00 91 04 ADDENDUM NUMBER NO. 4

Owner: Laguna Madre Water District
Project: Lift Station Nos. 1 and 37 Rehabilitation
Project No.: LMWD Bid # LS-20-07-01; TWDB Project No. 73730
Addendum No. 4
Addendum Date: September 1, 2020

Figure 2: Lift Station No. 37 - System Curve - One Pump

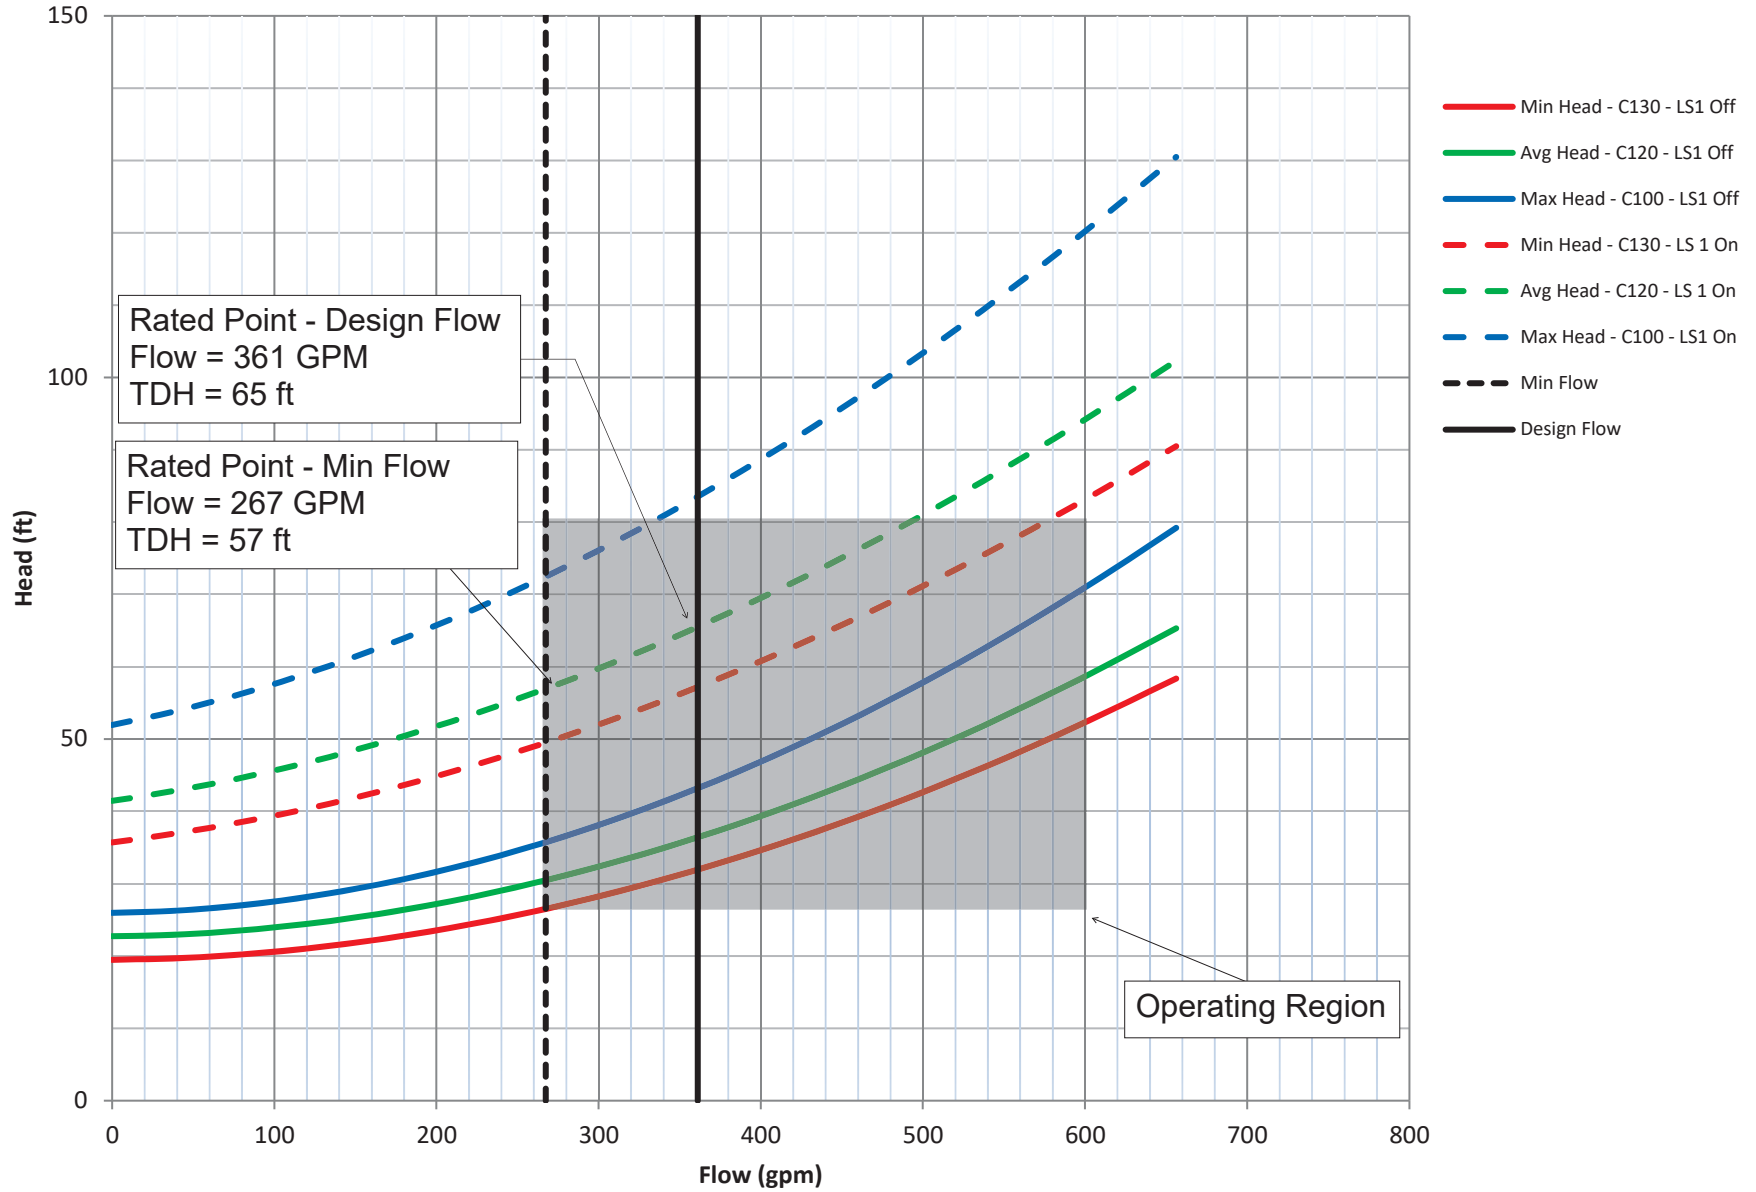
B. Insert Figure 2 – LS #37 System Curve immediately following Figure 1 – LS #1 System Curve.

LAGUNA MADRE WATER DISTRICT
LIFT STATION NOS. 1 AND 37 REHABILITATION
LIFT STATION NO. 37
SITE PLAN (ALTERNATE NO. 1)

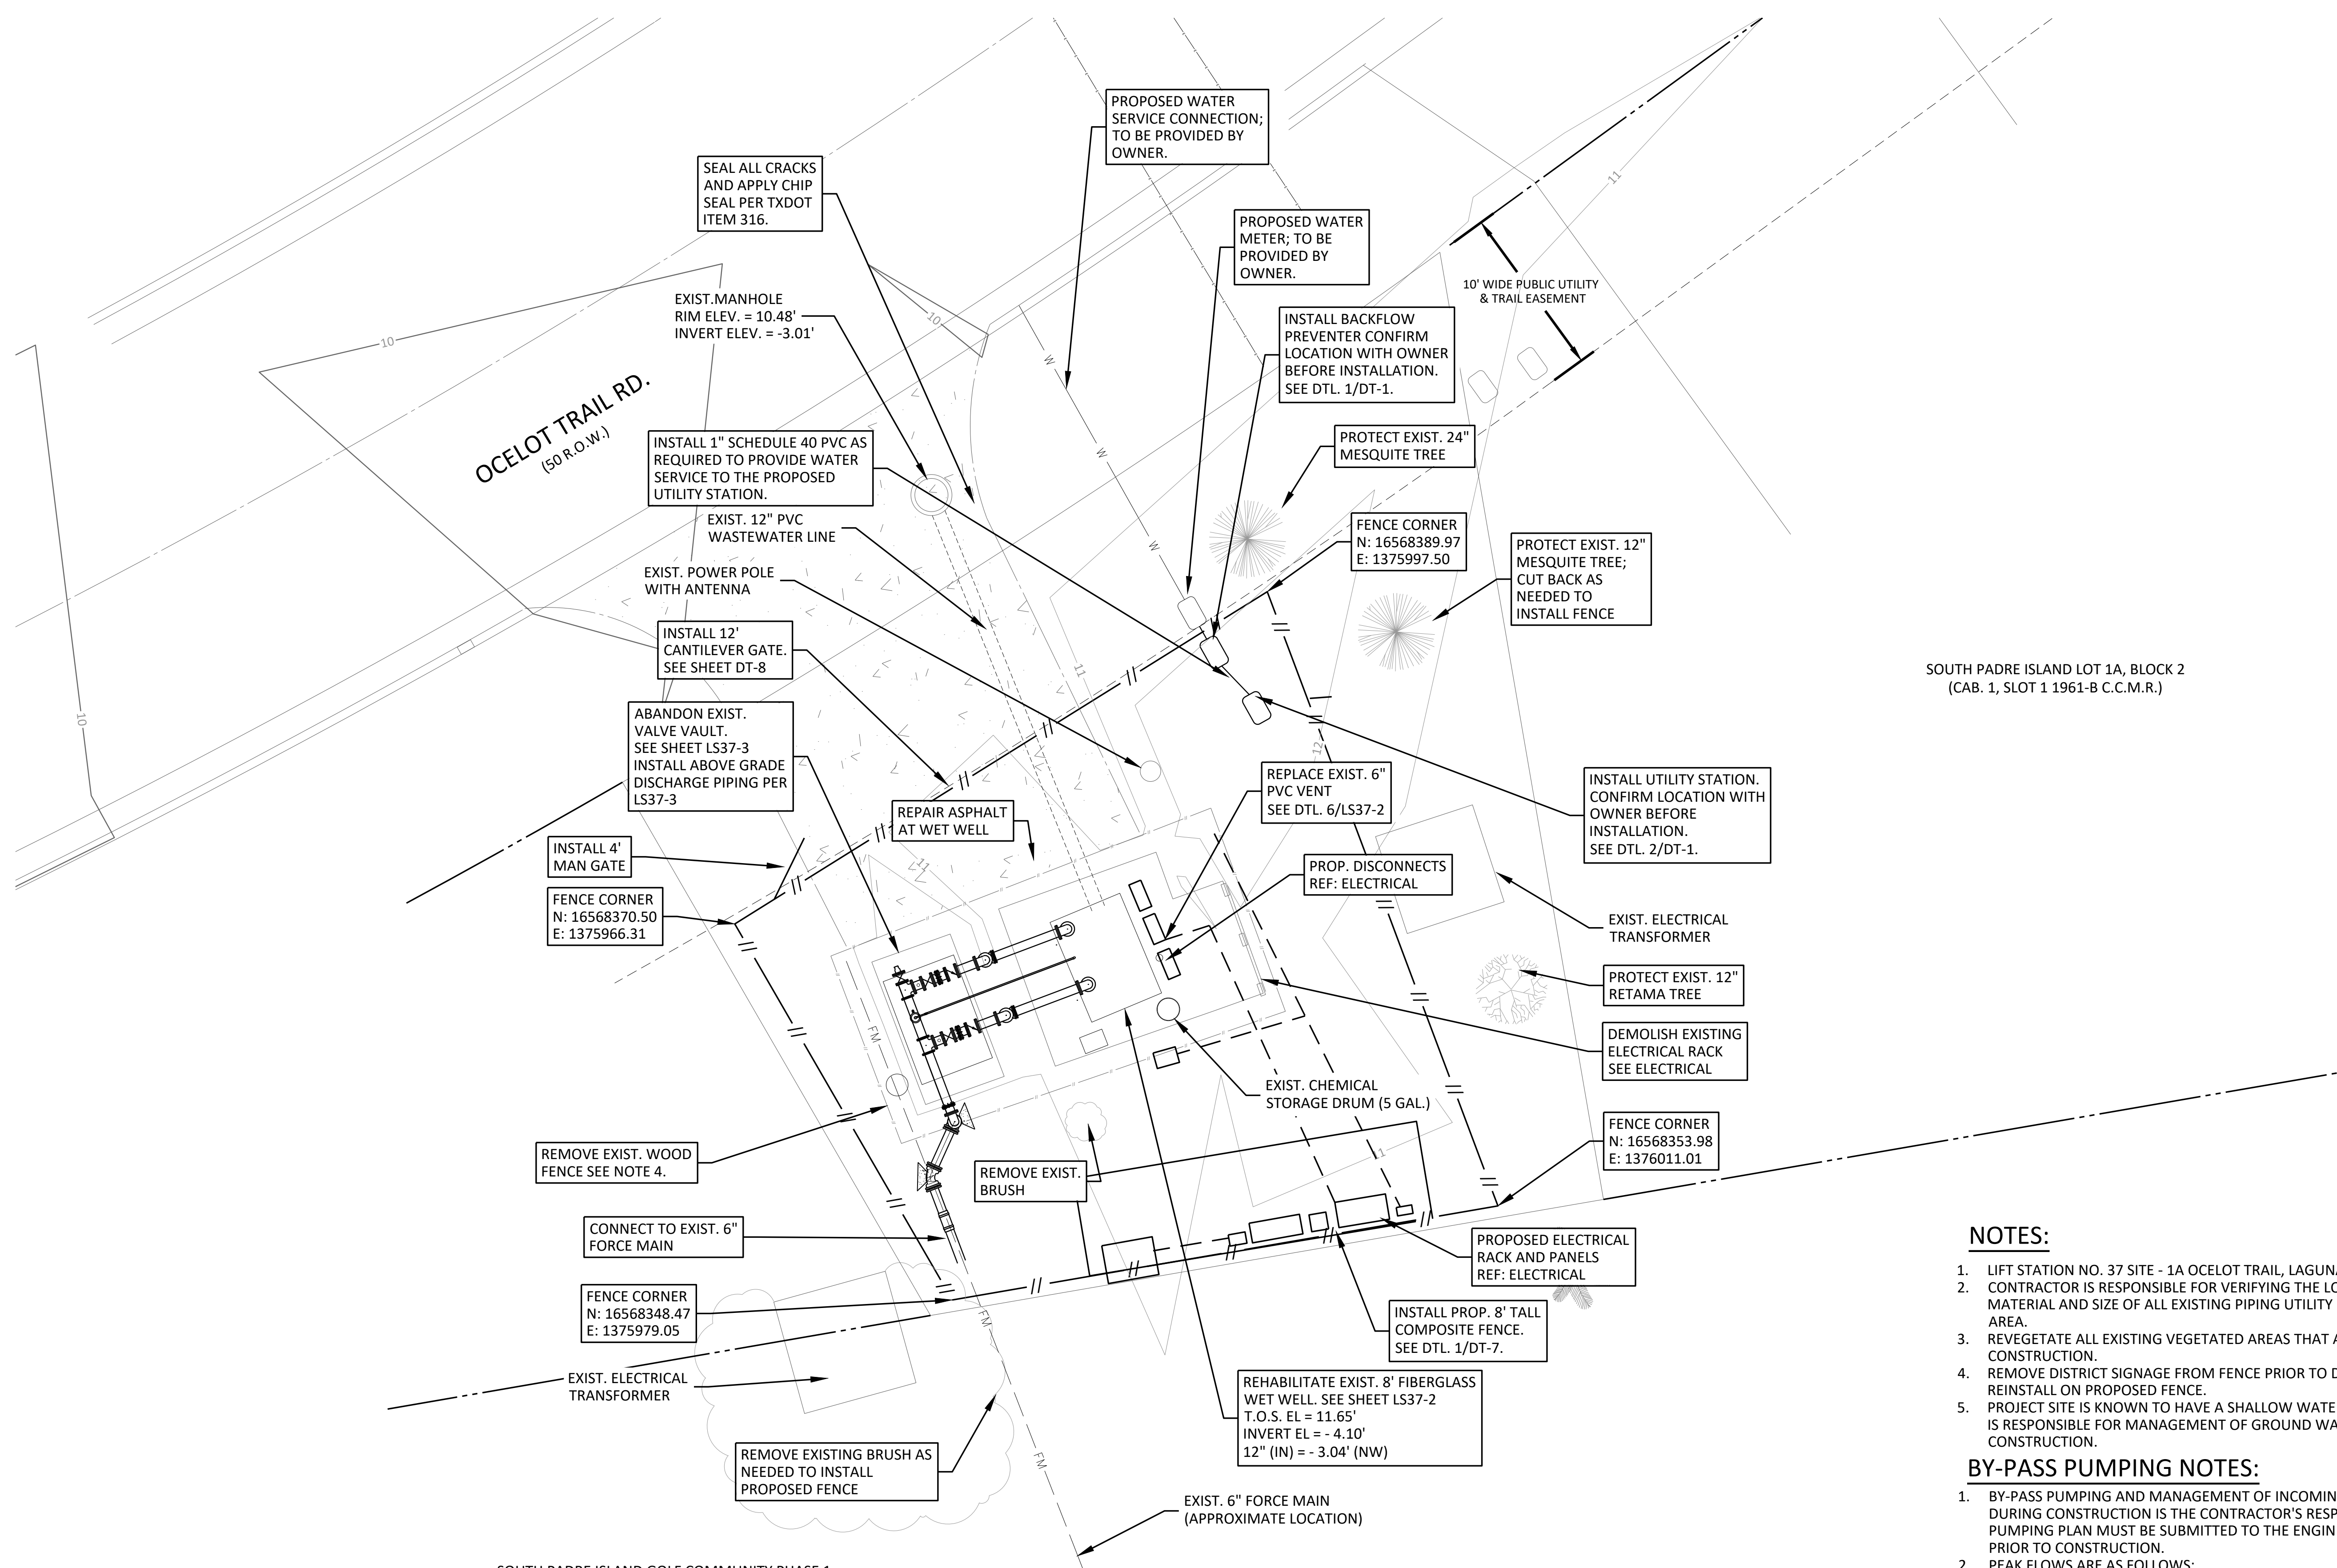
| Drawing No. | Drawing Title |
|-------------|---|
| LS37-A1-1 | Site Plan (Alternate No. 1) |
